RECREATIONAL VEHICLE WIRING

NONPERMANENT-TYPE

1.001 This addendum supplements Section 461-220-101, Issue 1. Place this pink sheet ahead of page 1 of the section.

Fig. 5.1—Securing C Weatherproof Cord in Telephone Set

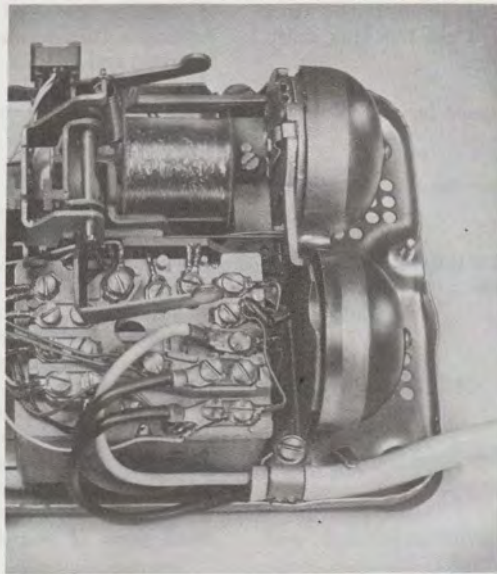
- Cord, Weatherproof, C (used with RV and boats, Fig. 5.1).

2.05.1 The C weatherproof cord is the same as the B weatherproof cord except that the female plug on the recreational vehicle or boat end is replaced with space-tipped leads for terminating

the cord directly in a 500- or 2500-type telephone set. An "S" hook assembly is provided for fastening the cord by means of the ringer mounting screw. Terminate the leads as follows: (BK) for tip, (W) for ring, and (G) for ground.
